# A comment on beam pipe shape

@ILD meeting in TILC08

# Beam pipe design of LDC

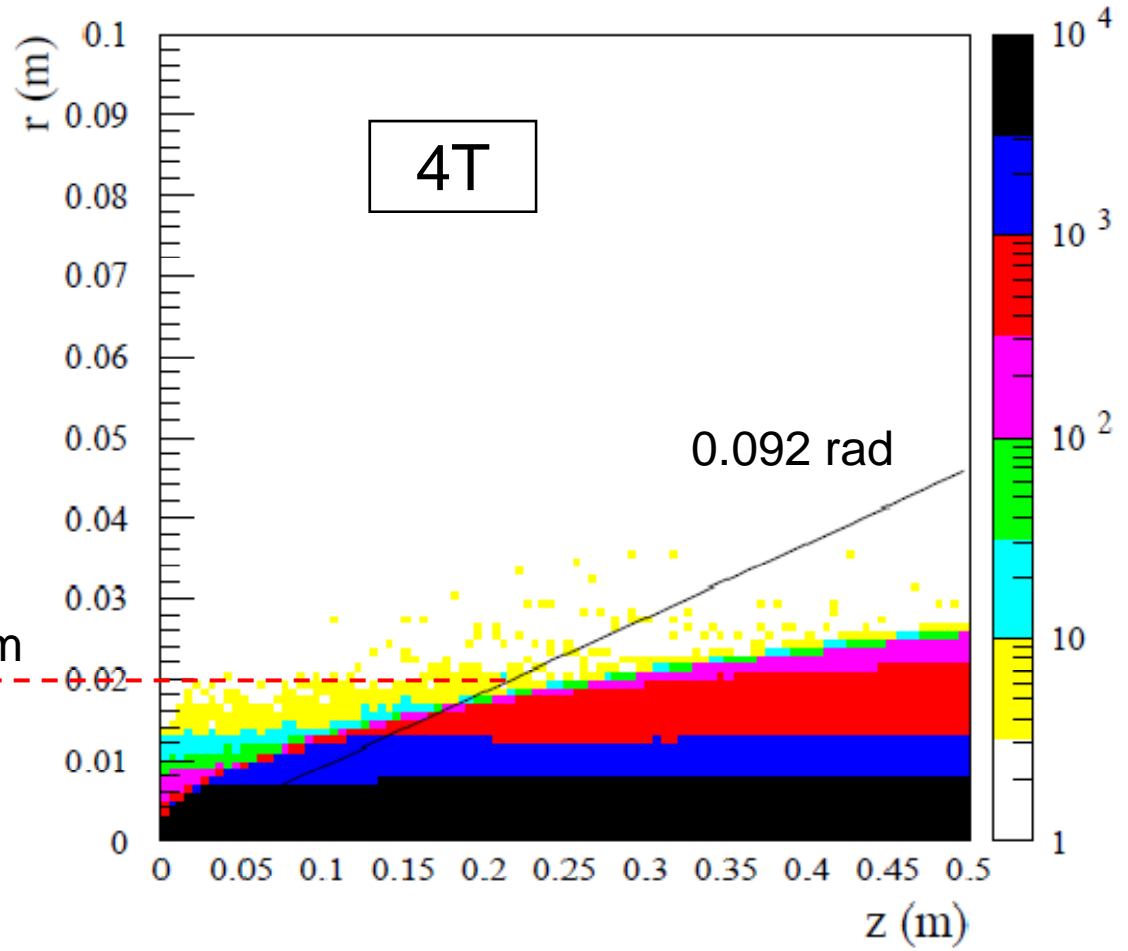
Single cone design  
is not preferable for  
VTX

- Large beam pipe radius at IP
- Loss of acceptance for low  $P_t$  charged tracks in the very forward region
- Mechanical stress to the very thin ( $t < 500\mu\text{m}$ ) Be pipe at IP
